NRC RAI Letter No. PTN-RAI-LTR-041

SRP Section: 02.05.01 - Basic Geologic and Seismic Information

NRC RAI Number: 02.05.01-27 (eRAI 6024)

Figure 1. Tectonic Sketch Map of Cuba, Modified after Reference 1

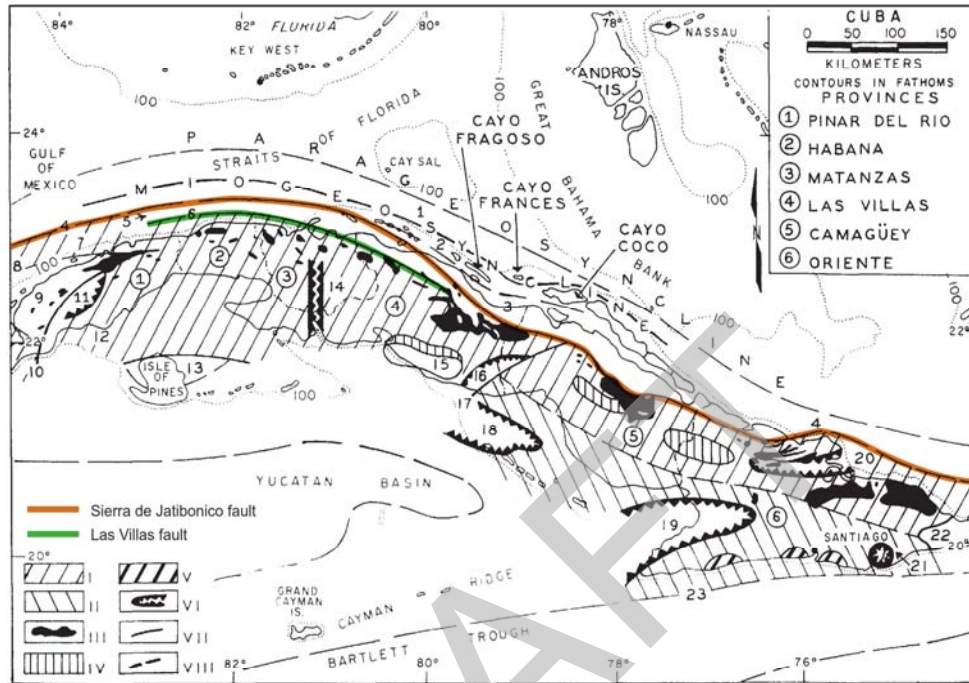
c) Discuss bathymetric evidence for the offshore location and recency of faulting along the Las Villas fault.

Reference 1 identifies the Las Villas fault as a “deep” fault of Cuba “whose length is approximately 800 kilometers, generally paralleling the island.” Despite this, the map in Reference 1 shows the Las Villas fault as approximately 220 miles (350 kilometers) long (Figure 1). As mapped in Reference 1, the Las Villas fault extends along the northern coast of Cuba from approximately 80°W to 83°W, transitioning from an onshore to an offshore structure near Carahatas, Cuba (Figure 1). The total offshore length of Khudoley’s Las Villas fault is approximately 120 miles (200 kilometers). Reference 1 does not describe the data that constrain the location and extent of the offshore portions of the Las Villas fault, but this is presumably based on bathymetric data because these are the primary data presented by the author.

Figure 3. Fault Map of Central Cuba Showing Earthquakes from the Project Phase 2 Earthquake Catalog

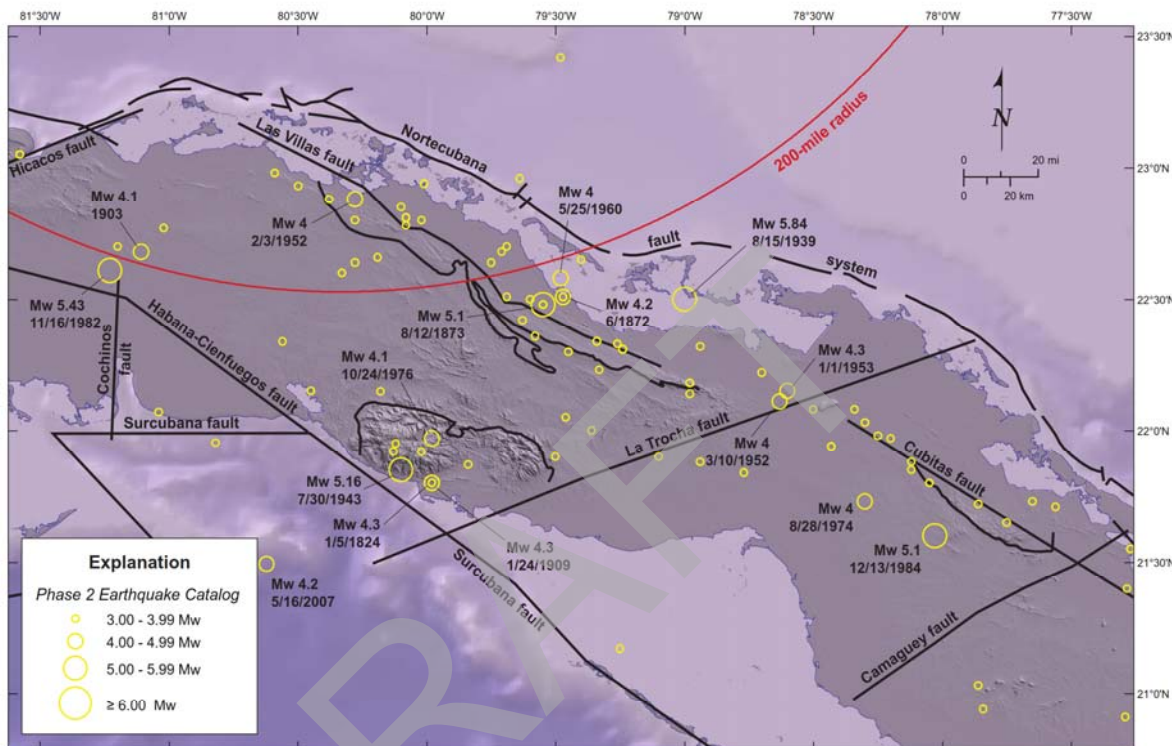
d) Address the alignment of epicenters shown on Figure 2.5.1-267 along the Las Villas fault with respect to its tectonic activity. Please plot the uncertainties in event locations and include this information in the discussion.

More recent depictions of the Las Villas fault indicate that this structure is located mostly or entirely onshore in central Cuba. For example, the depiction of the Las Villas fault on Figure 3 from Pardo (FSAR Subsection 2.5.1, Reference 439) extends offshore near Carahatas, Cuba and continues offshore to the northwest roughly parallel and close to the coast for only about 40 miles (65 kilometers) (Figure 3). Pardo (FSAR Subsection 2.5.1, Reference 439) does not describe bathymetric expression of this fault. Cotilla-Rodriguez et al. (FSAR Subsection 2.5.1, Reference 494) show the Las Villas fault as entirely onshore, and therefore it is not expressed in the bathymetry. Similarly, the 1:2,000,000 scale lineament map of Cuba from the *Nuevo Atlas Nacional de Cuba* (Reference 3, plate III.3.1-11) depicts and labels the Las Villas fault as an approximately 120-mile-long (190-kilometers-long), northwest-trending feature that is located entirely onshore. The 1:2,000,000 scale neotectonic map of Cuba from the same atlas (Reference 3, plate III.2.4-8) shows an unnamed fault in the vicinity of the Las Villas fault that is located entirely onshore. Based on its location, we assume that this unnamed fault is the Las Villas fault. Perez-Othon and Yarmoliuk (FSAR Subsection 2.5.1, Reference 848) show an unnamed fault on their 1:500,000 scale geologic map of Cuba in the vicinity of the Las Villas fault and this unnamed fault is located entirely onshore. Pushcharovskiy’s (FSAR Subsection 2.5.1, Reference 847) 1:500,000 scale tectonic map of Cuba depicts and labels the Las Villas fault as a thrust fault located entirely onshore.

At a larger scale, Figure 3 shows moderately sparse seismicity from the project Phase 2 earthquake catalog (shown on FSAR Figure 2.5.1-267) that may be roughly aligned with Pardo et al.'s (FSAR Subsection 2.5.1, Reference 439) depiction of the Las Villas fault. The project Phase 2 catalog is declustered and includes earthquakes of M_w 3 and above. These earthquakes include both instrumentally located earthquakes and pre-instrumental earthquakes whose locations are based on historical felt intensity reports. The accuracy of the instrument-derived earthquake locations is limited by the lack of permanent seismic recording stations in Cuba, especially for lower-magnitude earthquakes. In fact, many of the earthquake magnitudes and locations from the instrumental era are intensity-based as well, and therefore, the uncertainties in locations of Cuban earthquakes are both high and variable. The accuracy of intensity-based locations is a function of the number and reliability of felt reports, the population density and distribution, and other factors. Even for earthquakes with well-constrained intensity centers, there remains ambiguity in the location of the epicenter because of possible seismic wave directivity effects and other seismologic phenomena, including localized amplification of seismic waves from site effects such as basin structure.

A total of 33 earthquakes from the project Phase 2 earthquake catalog are located within approximately 6 miles (10 kilometers) of the Las Villas fault along its length. Of these, 29 are located northeast of the trace of this southwest-dipping fault, with the remaining four located southwest of the fault trace. The largest earthquake near the Las Villas fault is the August 12, 1873 M_w 5.1 earthquake, located approximately 3 miles (5 kilometers) northeast of the fault (Figure 3). Cotilla-Rodriguez et al. (FSAR Subsection 2.5.1, Reference 494) indicate focal mechanisms for these earthquakes are unavailable, so it is not possible to assess whether these possibly roughly aligned epicenters occurred on the Las Villas fault or on another fault or faults.
